SKIT
ADL

Nicolas Strohriegel 2022

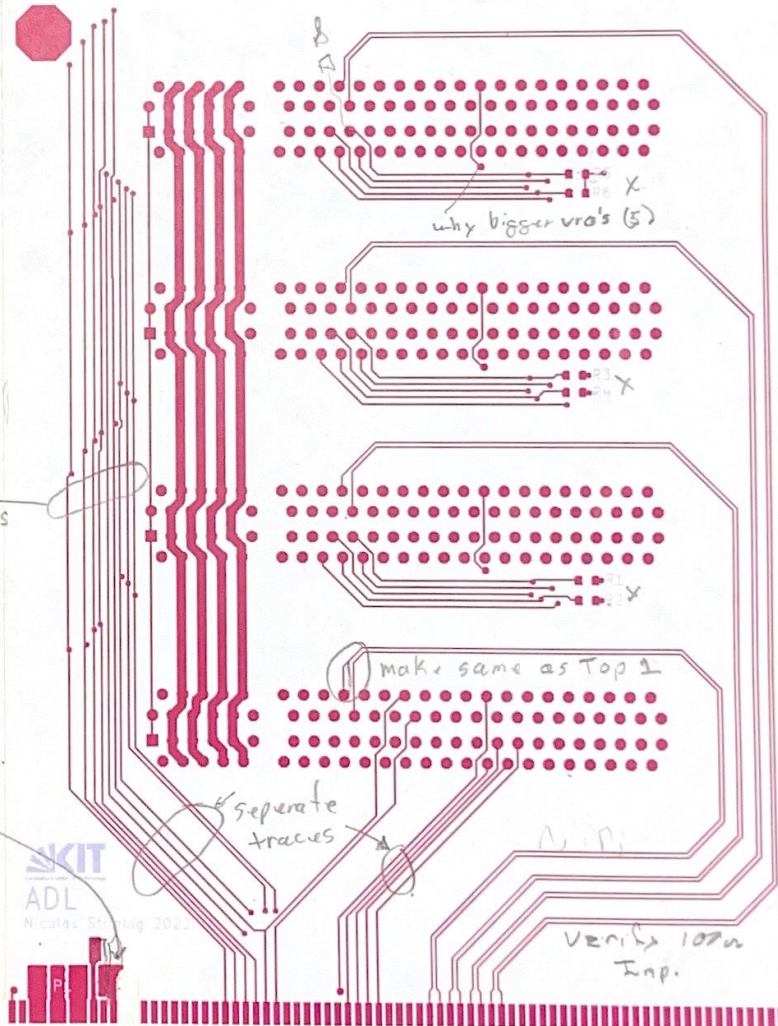
* Rule is termination resistor's
they should be at trace end of last
connection. NO "T" connections. Each
resistor should have its own via to gnd

seperate
Traces & Via's
move closer to
board edge

Trim back GND copper
to make trace next larger.

Veri 102n
Imp.

for all traces
put as much space
between for reduction
in x talk
